Office Action Summary	Application No. 10/559,772	Applicant(s) SANTINI ET AL.	
	Examiner KEEGAN GUMBS	Art Unit 4128

DETAILED ACTION

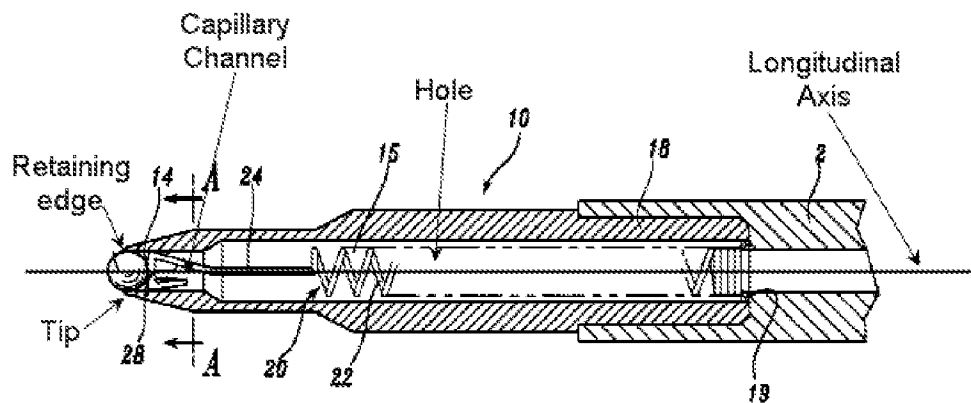
6. Claims 1-4 and 6 are rejected under 35 U.S.C. 102(b) as being anticipated by Kim (US 6,193,429 B1), hereinafter Kim.

Regarding claim 1, Kim discloses a ball point pen (10) comprising a reservoir (2) communicating with a hole (15, see the annotated figure below) connected to a capillary channel (15, seen the annotated figure below) of a tip (see the annotated figure below)

which is provided with a cavity (16) which seats the ball (30) for writing, the ball being kept pressed against a retaining edge (see the annotated figure below) of the cavity as a result of the thrust of a compression-resilient spring (20) terminating in a straight portion (24 and 28) which is aligned with the a longitudinal axis of the ball-point pen (see the annotated figure below) and a free end of the spring is in contact with the ball (see Figure 8), characterized in that the capillary channel has means (14) which, coming into contact with the straight portion of the spring, prevent it from becoming inclined with respect to the longitudinal axis of the ball-point pen (see Figure 9).

(Member (14) prevents the straight portion of the spring from being inclined; see Figures 8 and 9.)
